Attachment 2

DRESDEN UNIT 3

Proposed Technical Specification Page Changes

Revised Pages: 6

FIGURE 3.5-1
(Sheet 1 of 5)

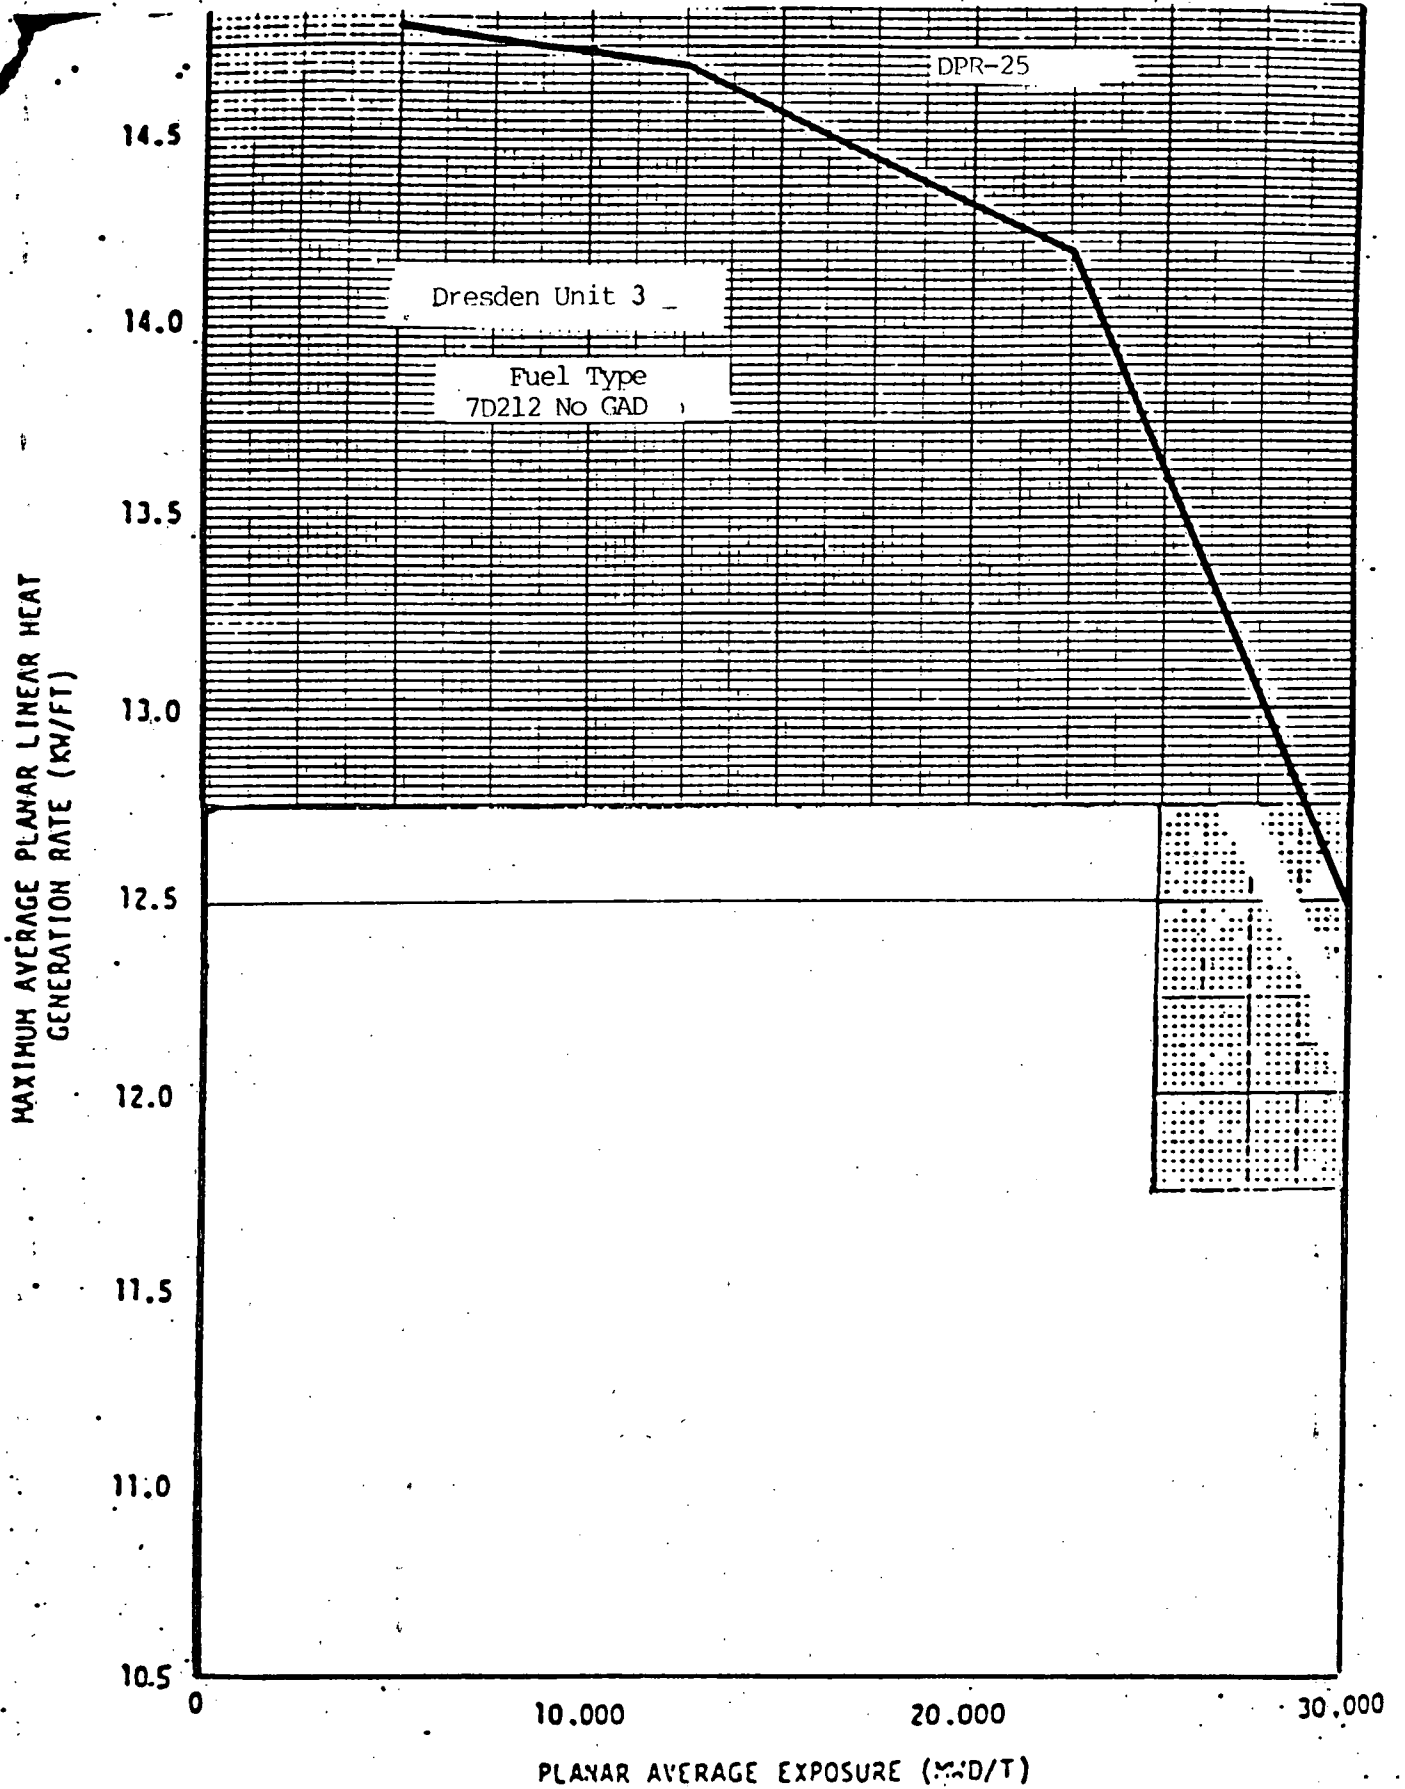
81C-1, Figure 3.5-1
(Sheet 1 of 5)

FIGURE 3.5-1
(Sheet 2 of 5)

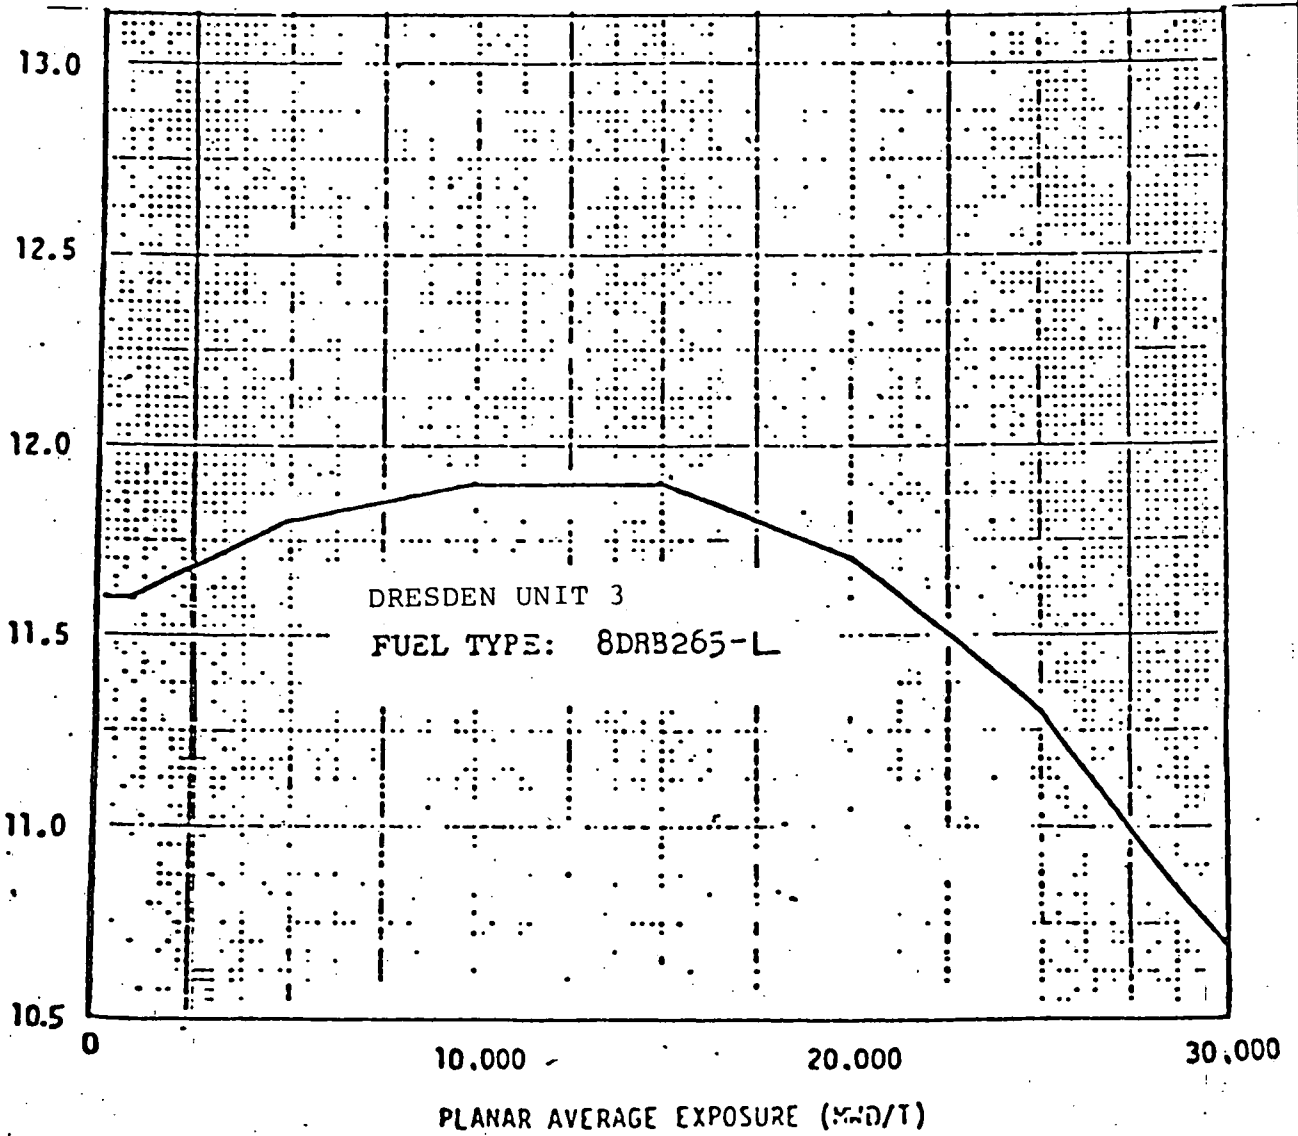
81C-2, Figure 3.5-1
(Sheet 2 of 5)

Figure 3.5-1
(Sheet 3 of 5)

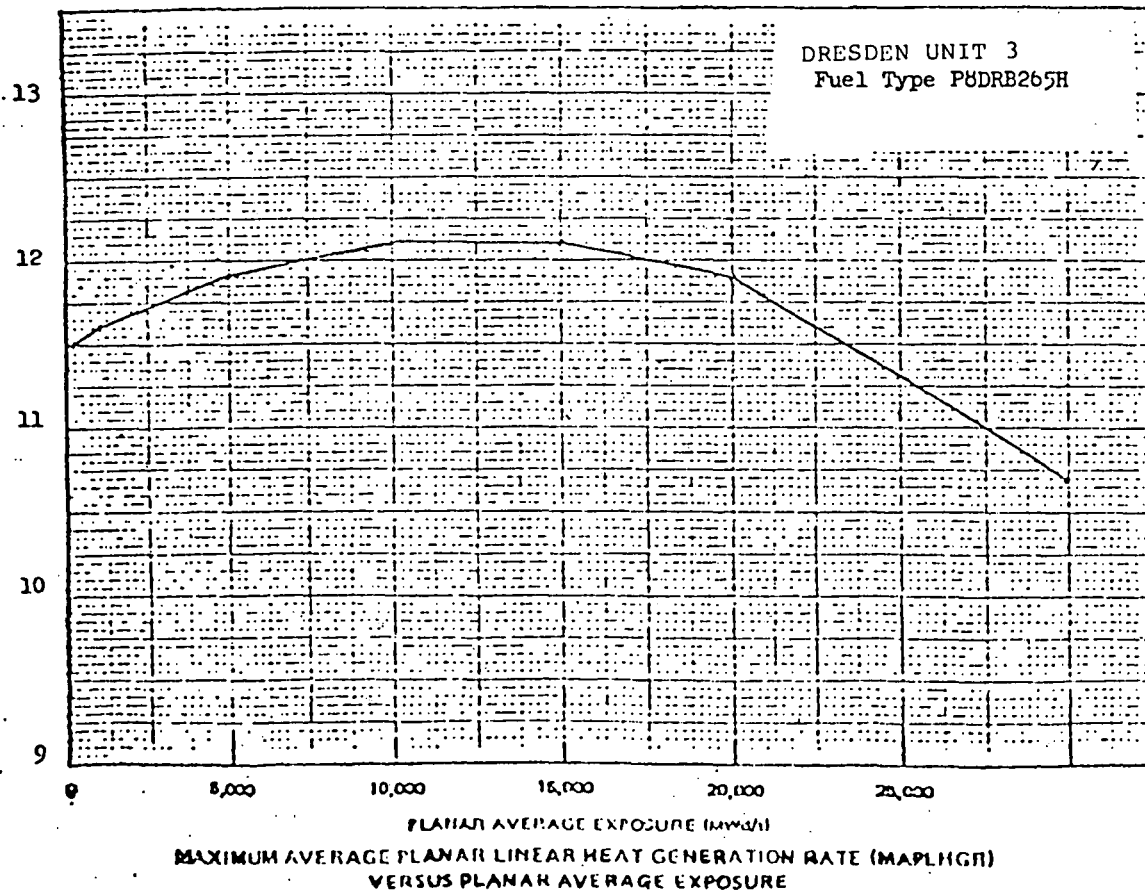
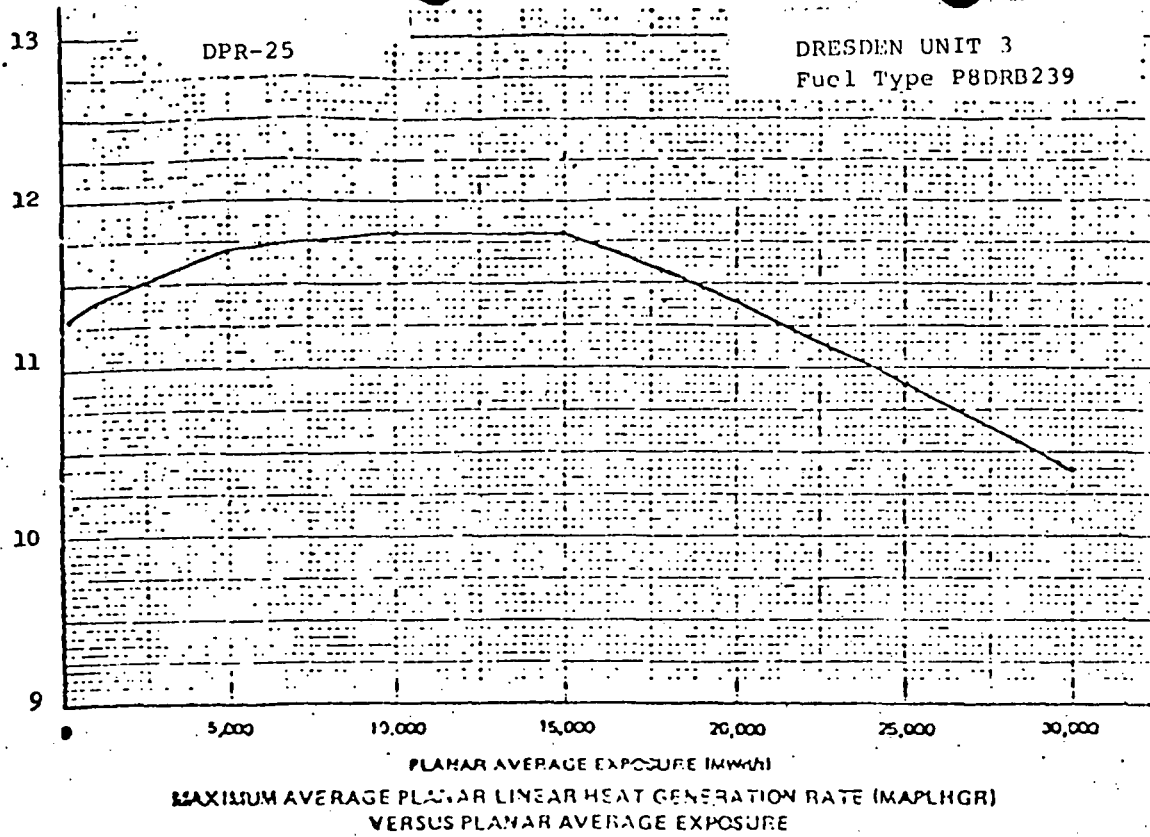
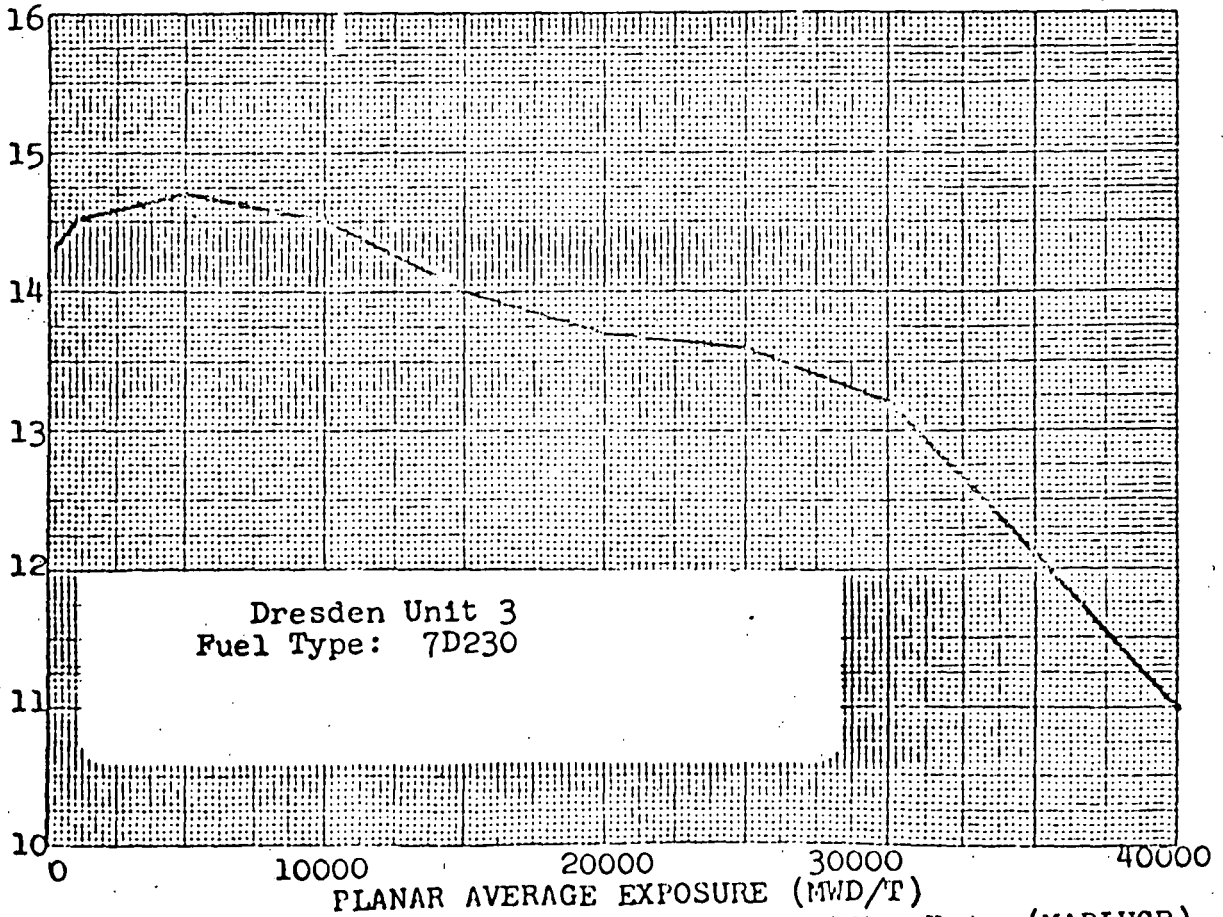
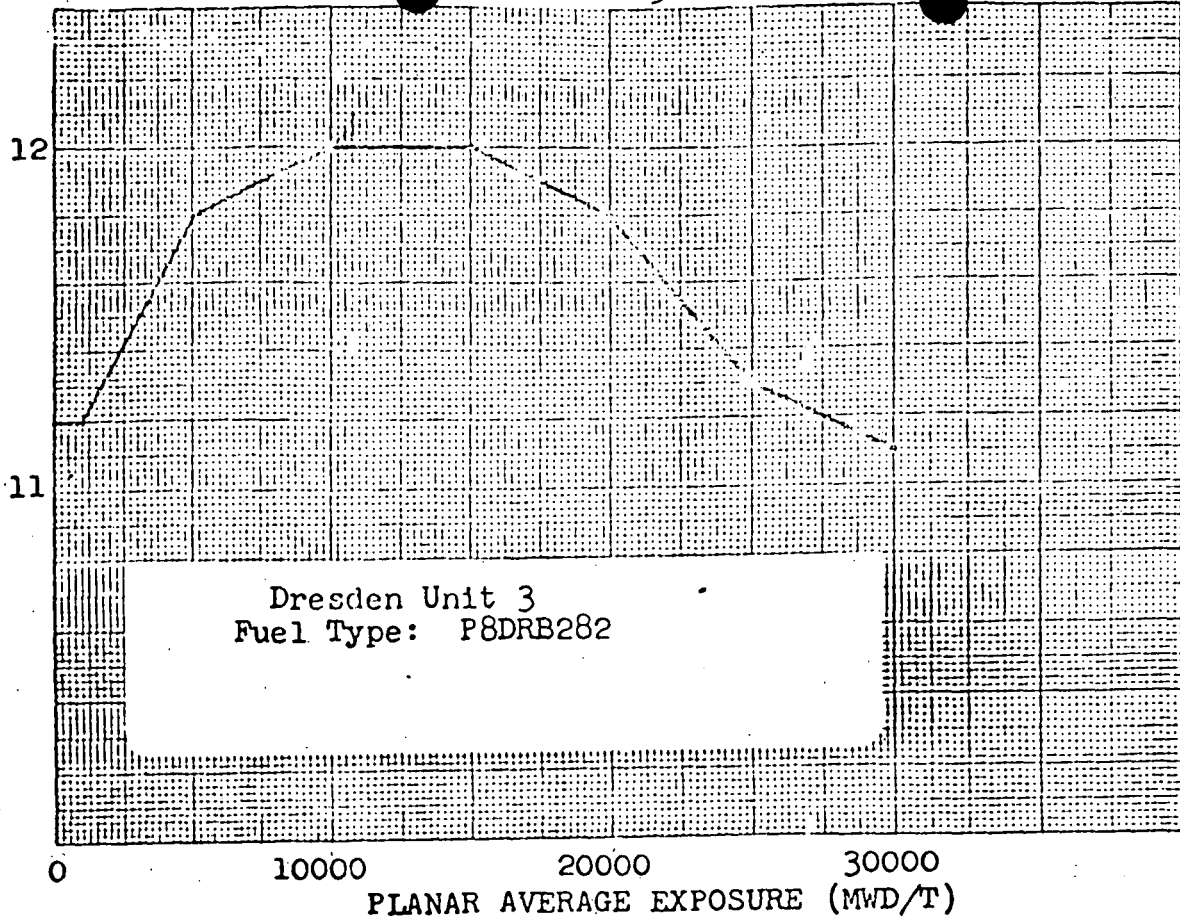
81C-3, Figure 3.5-1
(Sheet 3 of 5)

Figure 3.5-1 MAXIMUM AVERAGE PLANAR LINEAR HEAT GENERATION RATE (MAPLHGR) vs. PLANAR AVERAGE EXPOSURE
(Sheet 5 of 5)

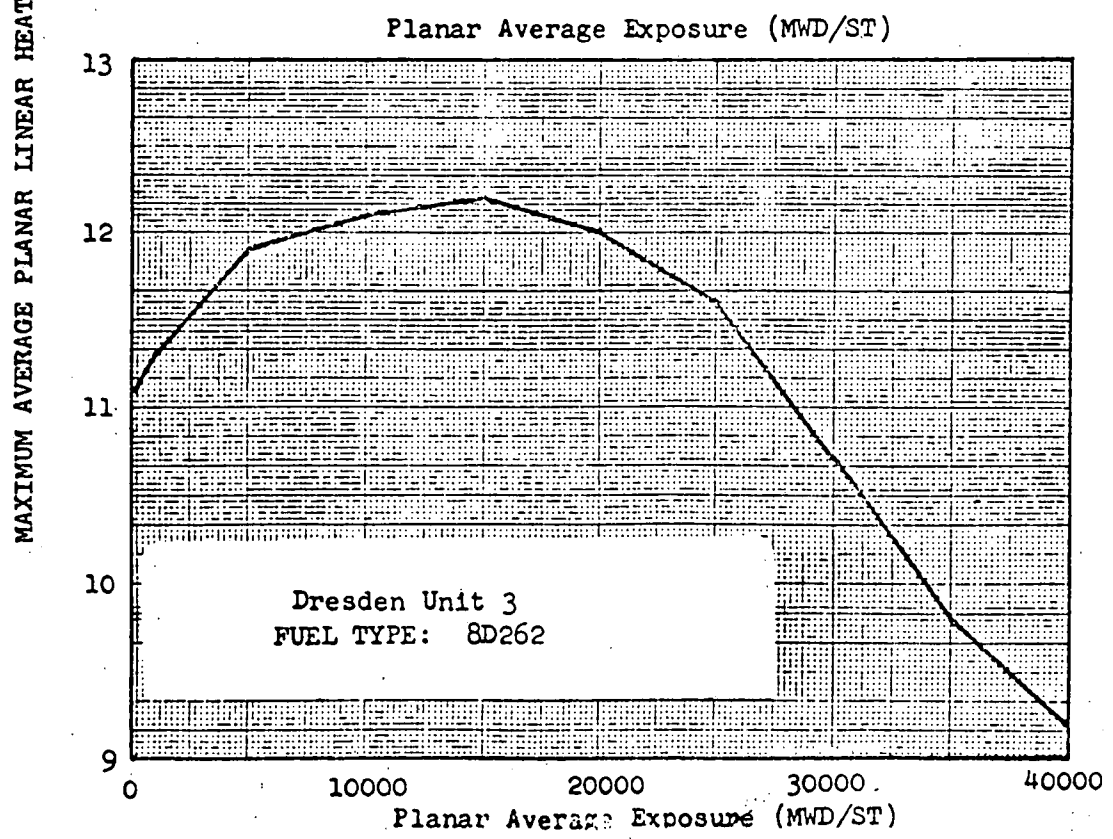
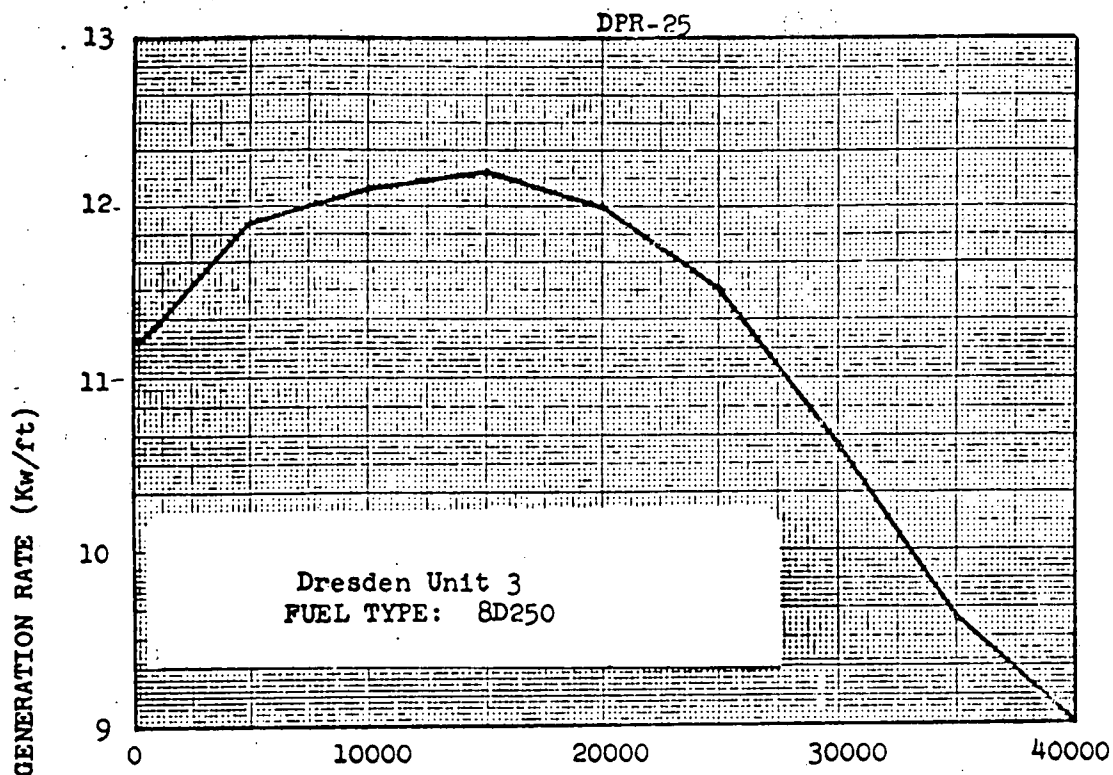
New Page: 81C-5, Figure 3.1-1
(Sheet 5 of 5)
